S E R V I C E N O T E

Supersedes:
E8358A-03

E8358A PNA Microwave Network Analyzers

Figure 1: A3 Front Panel Interface Board Assy without the Bracket

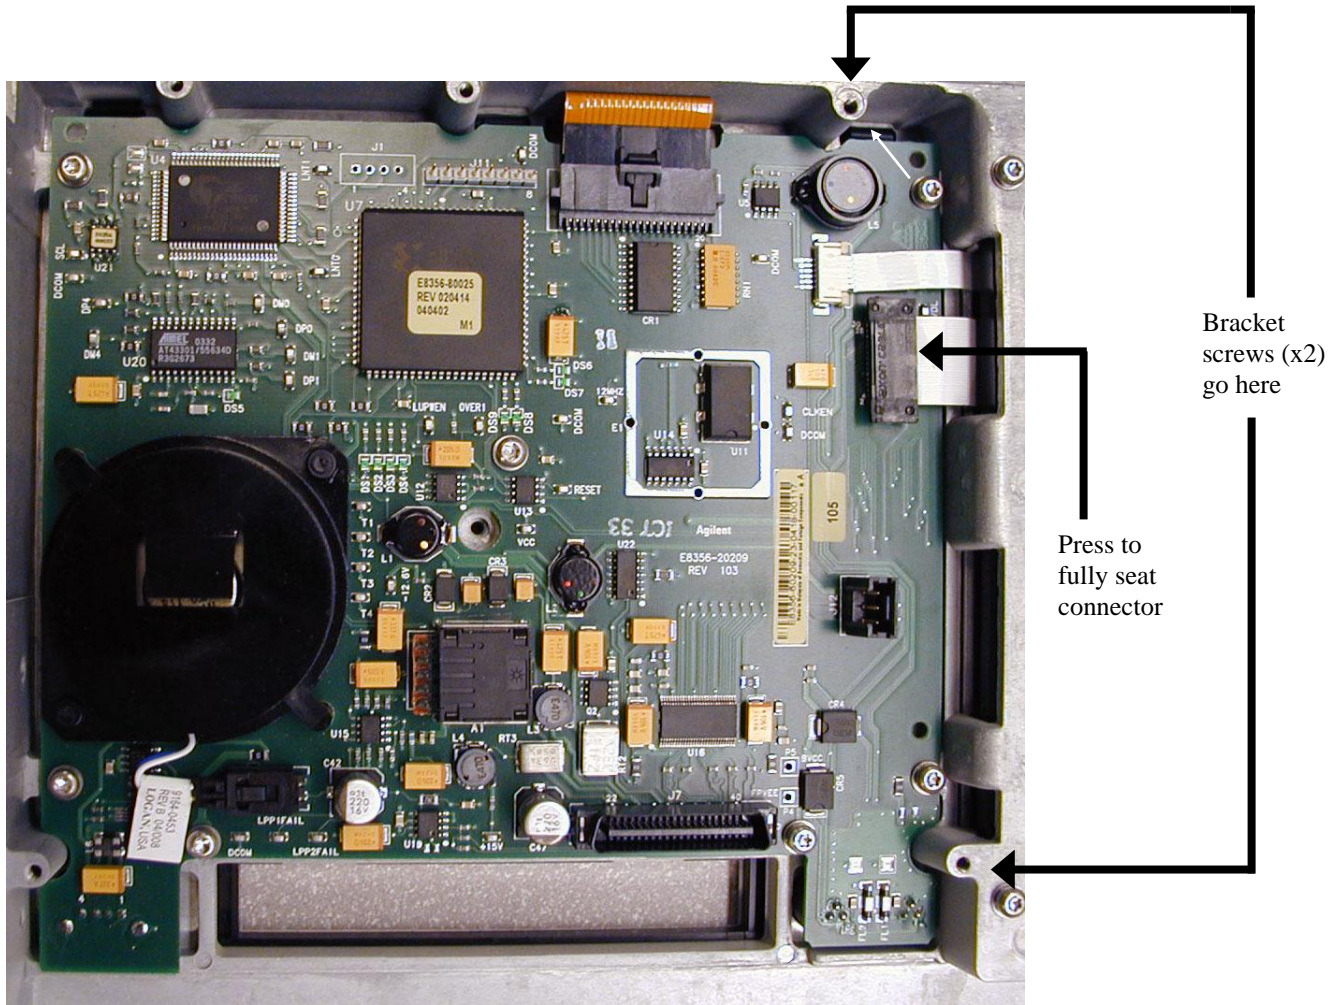
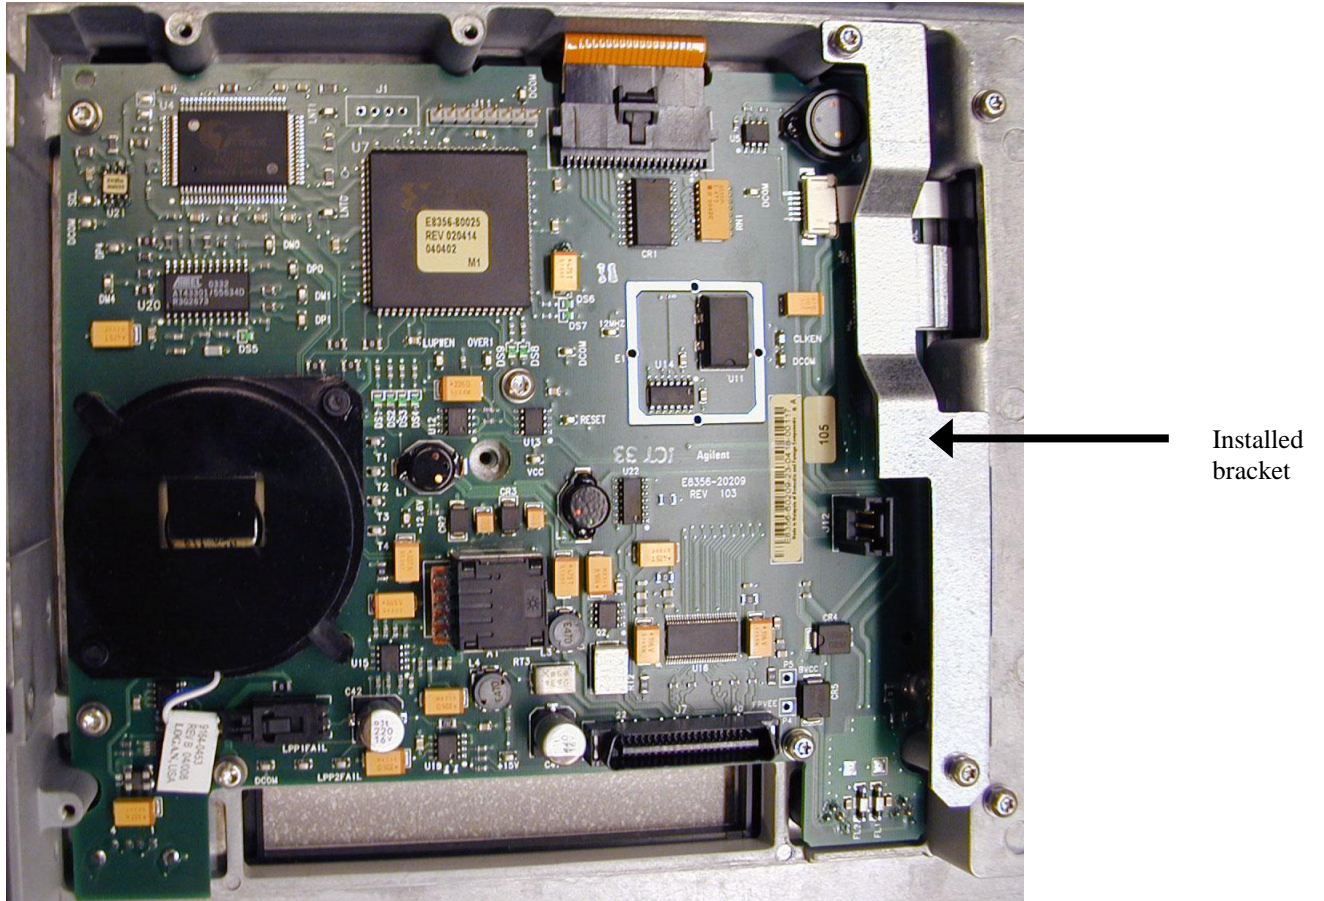
A connector of the ribbon cable (Agilent part number 8120-8409) that joins the front panel display to the front panel interface board can loosen, causing a display failure, unless a new bracket is installed. Because the failure rate has been very low, it is recommended that the bracket be installed only when there is an additional reason to remove the PNA front panel.

1. Refer to Figure 1 in this document:
 - Press down firmly on the ribbon cable's black connector.
 - Locate the two tapped holes for the bracket screws.
2. As shown in Figure 2 in this document, position the bracket so that its holes line-up with the two holes you located in the previous step.
3. Hand-start the two screws, and then torque both to 9 in-lbs.
4. Reinstall the PNA Front Panel by following the Service Guide instructions in the "Replacement Procedure." This is located on the same page as the "Removal Procedure" used previously in step 7.
